City of Portland, Oregon
Bureau of Development Services
Land Use Services
FROM CONCEPT TO CONSTRUCTION

NOTICE OF A TYPE II_x DECISION ON A PROPOSAL IN YOUR NEIGHBORHOOD

CASE FILE NUMBER: LU 22-144602 LDP

Proposal:

SHEET 3 OF 5	<p>6445 SW FALLBROOK PLACE, SUITE 100 BEAVERTON, OREGON 97008 TEL: (503) 746-8812 FAX: (503) 635-9592 www.emeriodesign.com</p>	PRELIMINARY PLAT	12320 SW 60TH AVENUE TAX MAP T1S R1E 31CD TAX LOT 1800 PORTLAND, OREGON

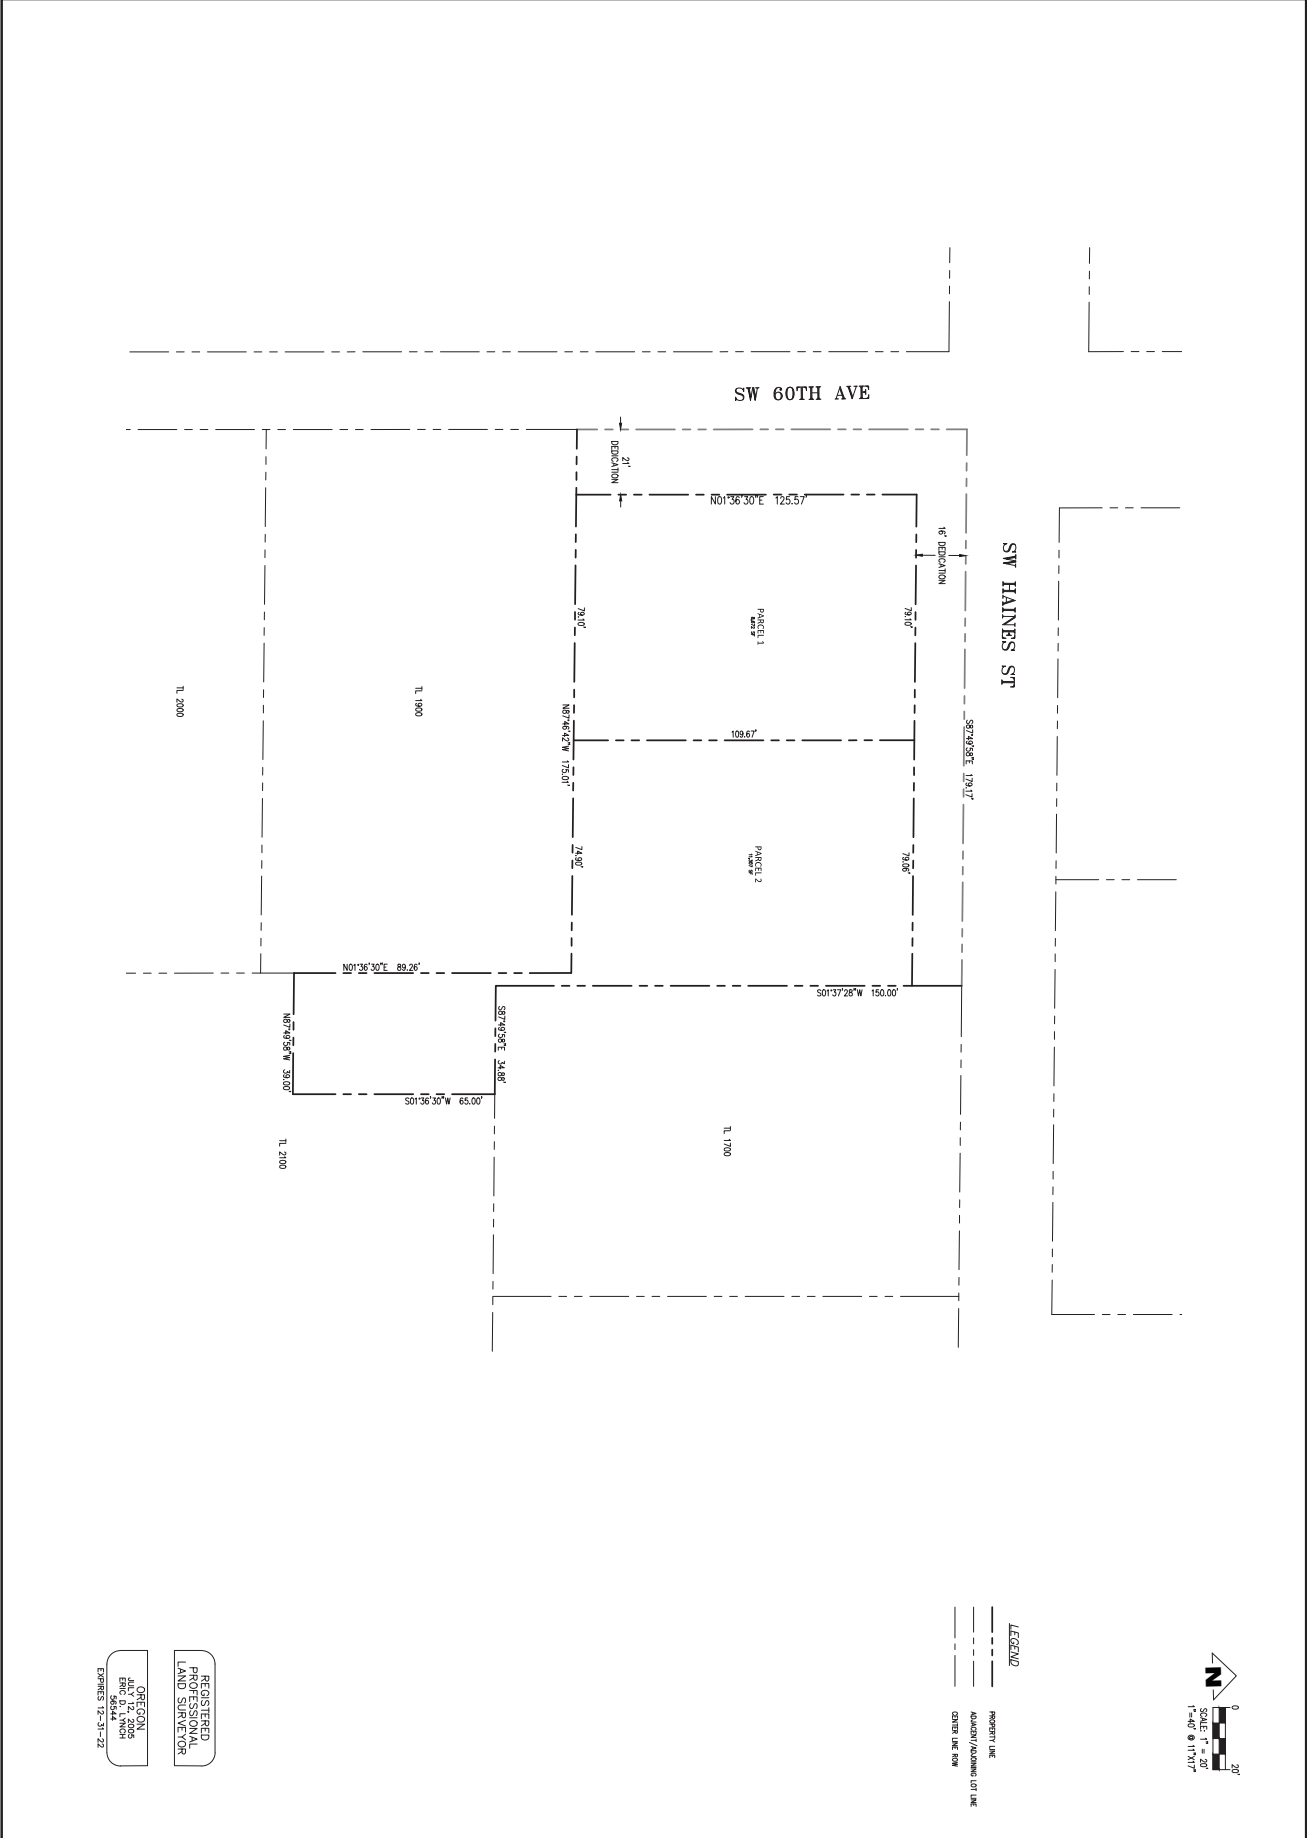
- The clearing and grading plan (Exhibit C.3) identifies a stockpile area within the root protection zone of Tree #5. This stockpile area must be moved to a location outside of a root protection zone.
- Though onsite tree protection fencing is proposed for Trees #5 and 6, there is no barrier to prevent vehicular access from SW Haines Street into the required root protection zones. During site preparation, demolition and construction, a barrier, such as construction fencing, must be provided on the north side of Trees #5 and 6 in order to prevent vehicular access into the tree protection zones between Tree #5 and 6, unless an alternative plan is approved by Urban Forestry.

In addition, no clearing and grading will be permitted within the root protection zones of the trees on the site that are required to be preserved. The Preliminary Clearing and Erosion Control Plan includes a stockpile area within the root protection zone of Tree #5, however, as conditioned within this report, the stockpile area must be accommodated elsewhere onsite. Preserving these trees will help limit erosion by assuring that the tree roots will help to hold the soil in place. Topsoil storage and general stockpiling on the site should only occur if it will not create any additional erosion concerns as recommended by the geotechnical engineer.

- o The stockpile area identified within the root protection zone of Tree #5 on the Preliminary Clearing and Grading Plan (Exhibit C.3) must be moved to a location outside of a root protection zone.
 - o During demolition and site preparation, a barrier, such as construction fencing, must be incorporated on the north side of Trees #5 and 6 in order to prevent vehicular access into the tree protection zones between Tree #5 and 6, unless an alternative plan is approved by Urban Forestry.
3. The applicant shall meet the requirements of the Site Development Section of the Bureau of Development Services for the decommissioning the septic system on the site.

- o The stockpile area identified within the root protection zone of Tree #5 on the Preliminary Clearing and Grading Plan (Exhibit C.3) must be moved to a location outside of a root protection zone.
